FROM STA. 192+00	TO STA. 193+06
PROJECT NAME MORETOWN-MIDDLESEX	NO. RSEGRS0167 (9)
SURVEYED BY MOREAU	PLOTTED 02/29/88
SHEET 92	01/86 0105
OF 243 SHEETS

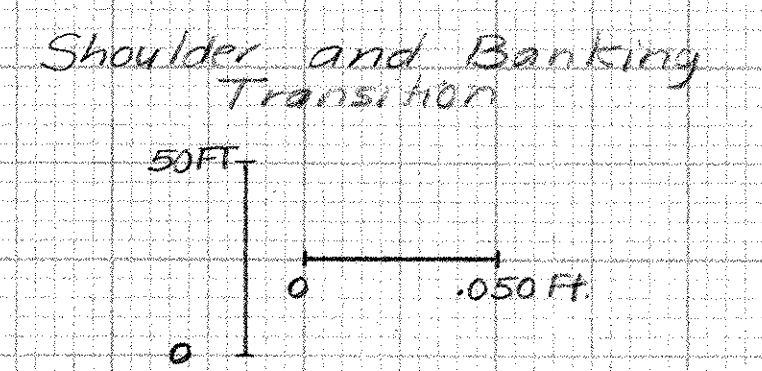
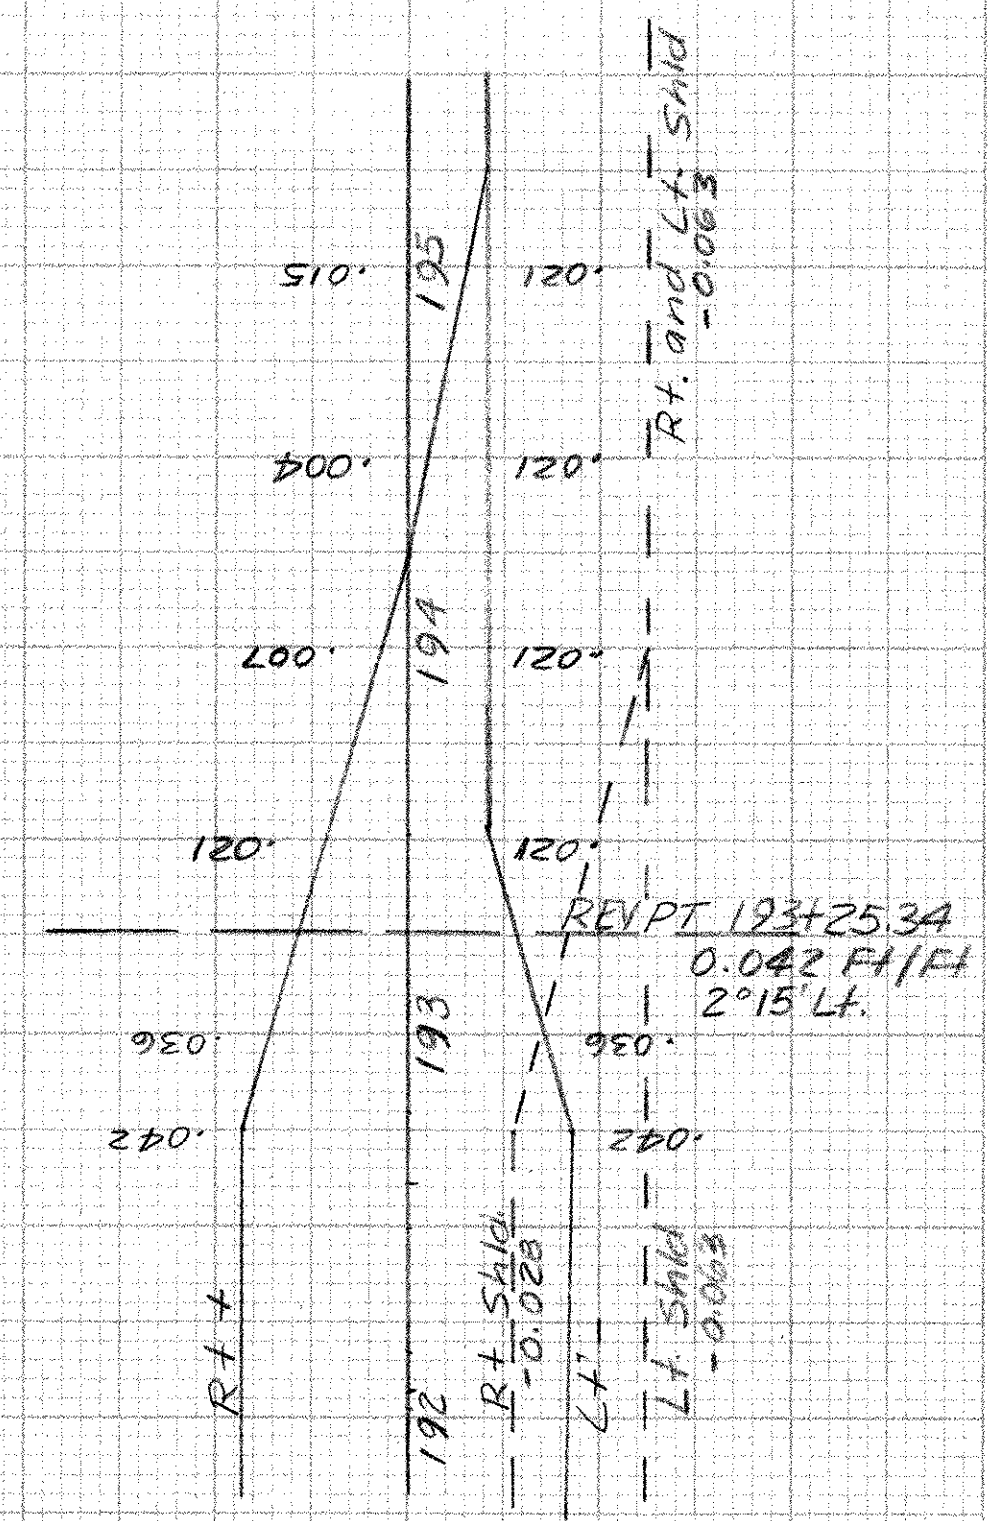
Take Area Excavated During Installation of 60" Culvert  
No Common Exc - WRF 10-16-02
